Access Compliance Report Public Rights-of-Way (Curb Ramps)

Main Street: N/A Cross Street: CRAWFORD_CANYON_RD Location: SW

ADA ID: RPAT220301120359 Ramp Type: Type 6 - Directional 1 Initial Pass/Fail: Fail Overall Compliance: No Severity Score: 0

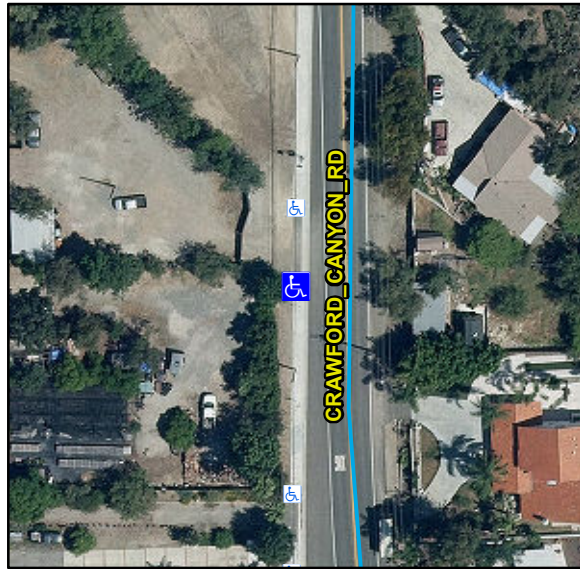
Surveyor Notes:

N/A

Possible Solutions:

Remove & Replace Entire Ramp.

STD 1115
